Columbia County Building Permit

Columbia County Building Permit Application

From: The Columbia County Building & Zoning Department
Plan Review
135 NE Hernando Av.
P.O. Box 1529
Lake City Florida 32056-1529

On the date of March 19, 2009 application 0903-29 and plans were reviewed for compliance of the 2007 Florida building code. The documents and plans submitted are for construction of a Group U Utility structure.

ANCHOR BOLT PLAN

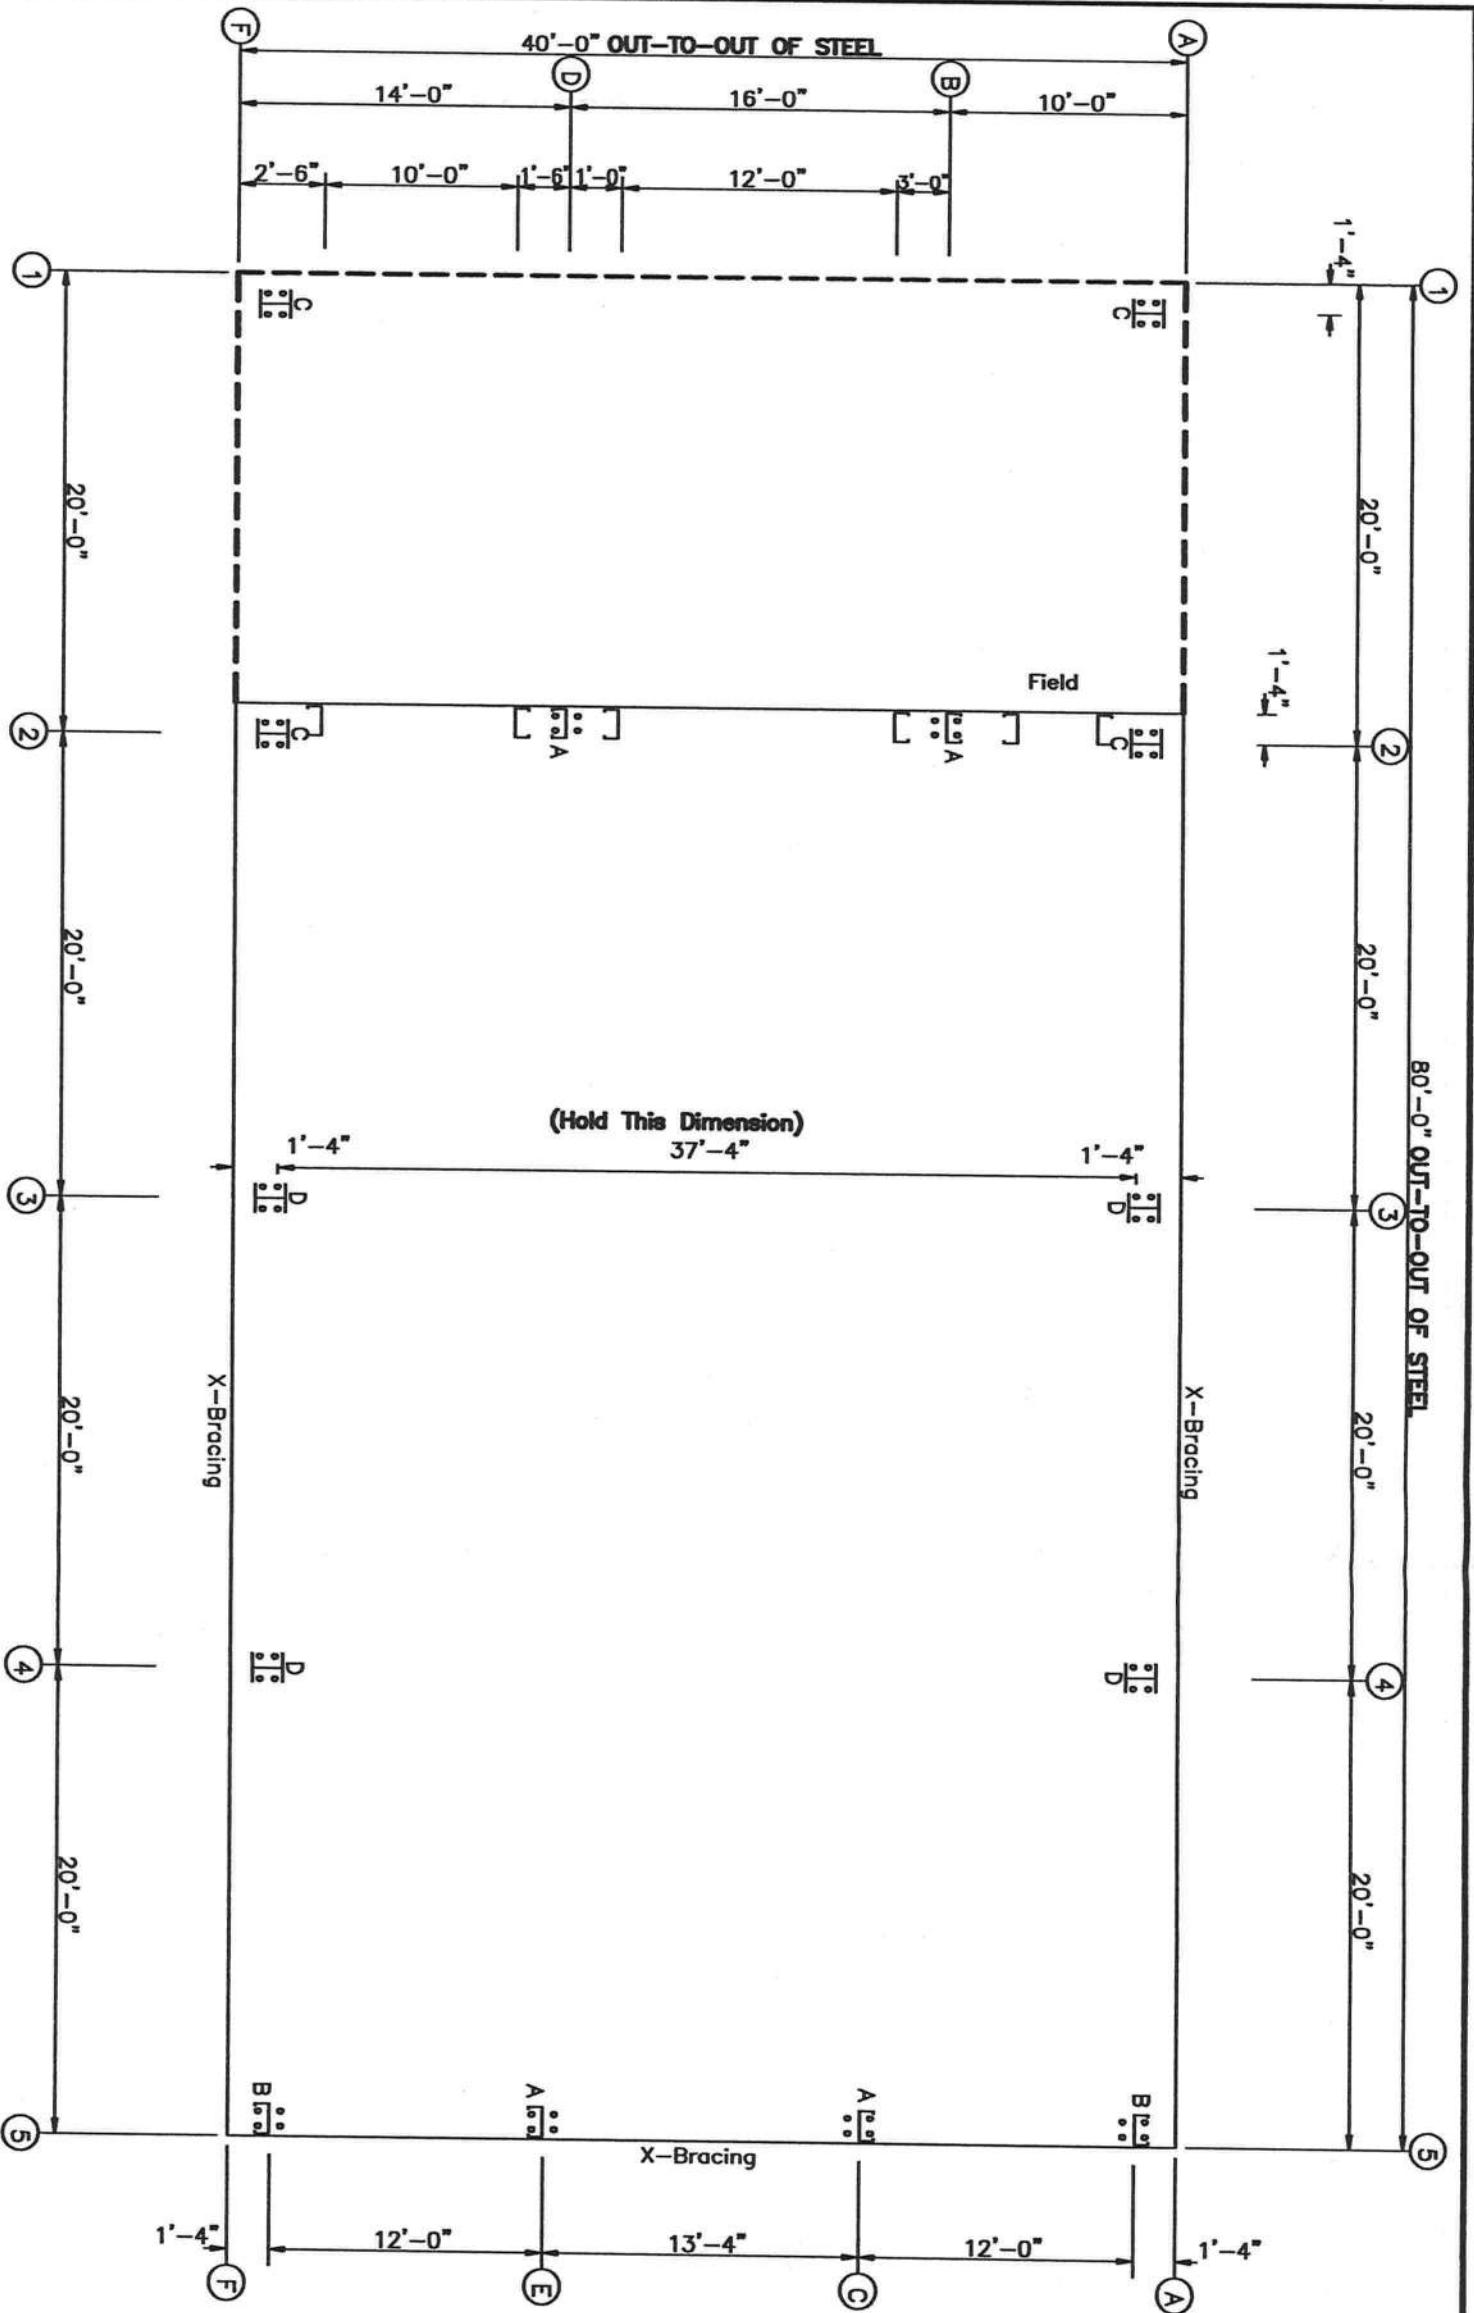
On sheet F1 of the plans under the anchor bolt plan general noted number two: "The metal building manufacture is not responsible for the project foundation design. The foundation design is the responsibility of a registered professional engineer familiar with the local site condition." Please submit two sets of the foundation plans, one set of the foundation plans will be return at permit issuance to become the field construction set.
